Applicant: Airbus U.S. Manufacturing Facility  
[Greg.Rensink@airbus.com](mailto:Greg.Rensink@airbus.com)  
Form 442 File Number: 1684-EX-CN-2023  
Form 442 Confirmation Number: EL265365  
Correspondence Reference Number: 81792  
Date of Original Email: 11/16/2023

Thank you for your reply. See below in response to your request for more information, **1) thru 6)**.

This specific request is for a new GPS repeater installed between Bay3 / Bay4 of Building 18.

### Hangar 18 Dimensions (92m Wide x 81m Deep)

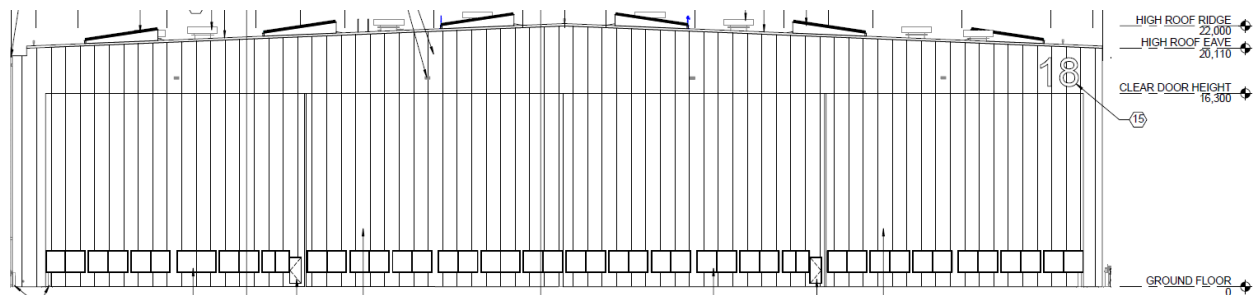
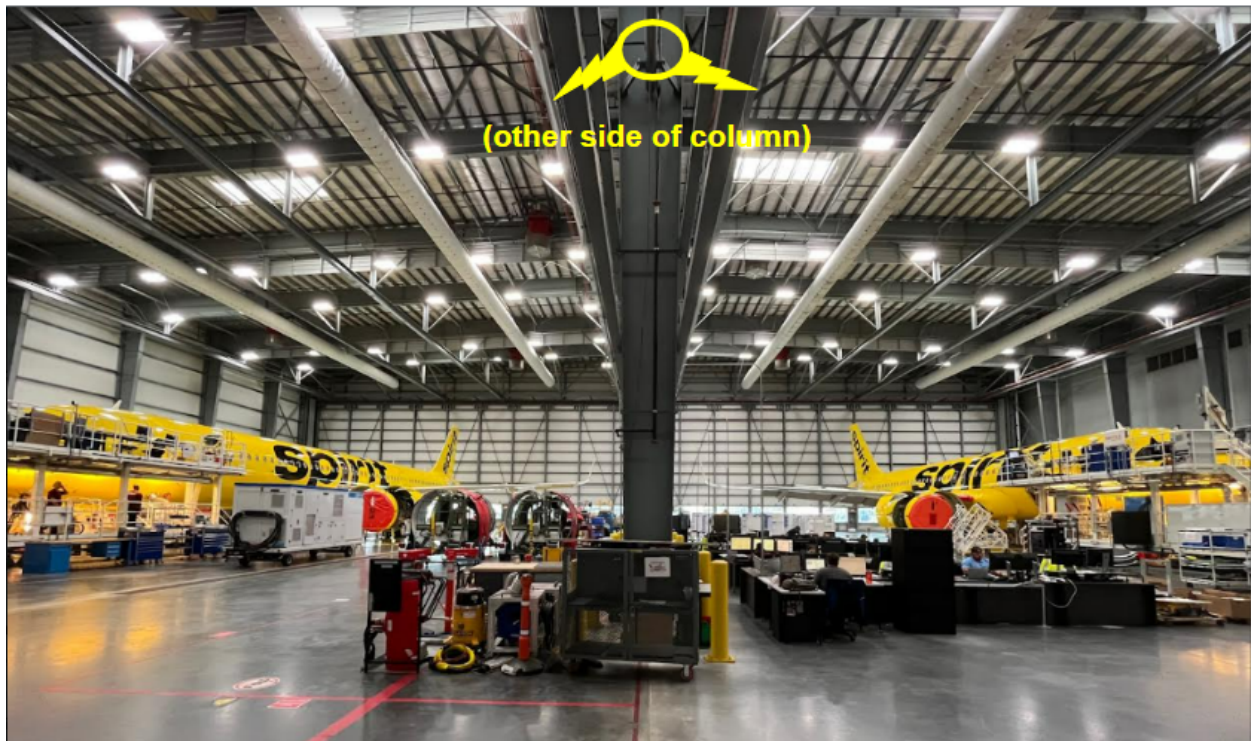
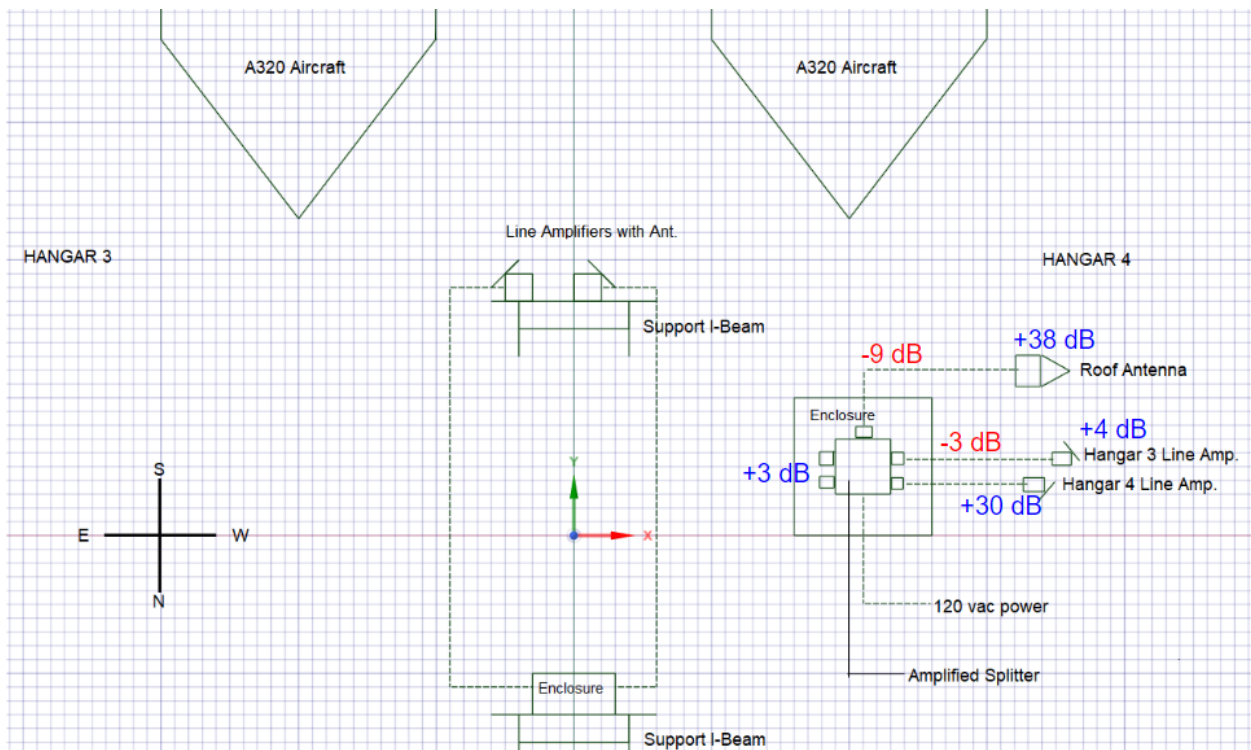
**1) Please submit a detailed application narrative. Describe the objectives you wish to accomplish. Manufacturer technical data sheet is not a narrative. What is the application for the frequency request?**

The Building 18 dimensions are: 92m Wide x 81m Deep x 22m High. The GPS Repeater system includes a receiving antenna that is connected to two re-radiating antennas through a splitter and two line amplifiers. The re-radiating antennas are installed 55m from the outer wall (which can fully open for aircraft ingress / egress), and pointed at the nose of the two aircraft where the aircraft GPS receiver antennas are installed. The GPS Repeater system can be easily unplugged from the ground when not needed.

Re-radiating antennas are installed 55m from the outer wall

Re-radiating antennas are pointed at the nose of the two aircraft (Net System Gain = +63 dB)
